CONSEIL SECURITE
CIRCULAIRE DE SECURITE N° 197

Objet: remise à hauteur du système de libération des parachutes tandem fabriqué aux USA

Product Service Bulletin

PSB Number: PSB-10092020

Figure-2

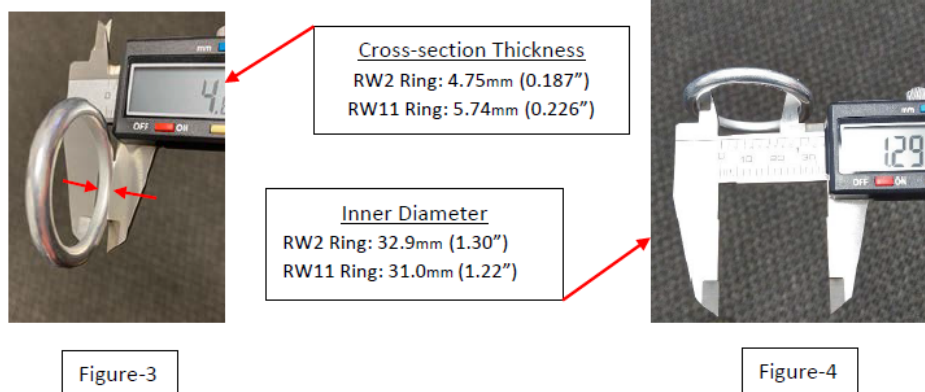
Background: Recent reports of "bent rings" on tandem main risers are of great concern. At least one after-market manufacturer of obsolete and unapproved tandem risers is using RW2 rings or similar rings, which were discontinued for tandem use in 1996 due to "bent ring" issues. These rings pass a proof load of 500 lbs. and begin to distort at 2500 lbs.

Two (2) sets of tandem risers were recently discovered with bent rings. This pair bent after one (1) jump; a second pair had approximately 30 jumps.

Compliance: **MANDATORY** – REPLACE BEFORE THE NEXT JUMP.

RW2 rings (or similar size rings) have a cross-section thickness of less than 5mm (0.197"). Risers with these dimensions should be permanently grounded for tandem use.
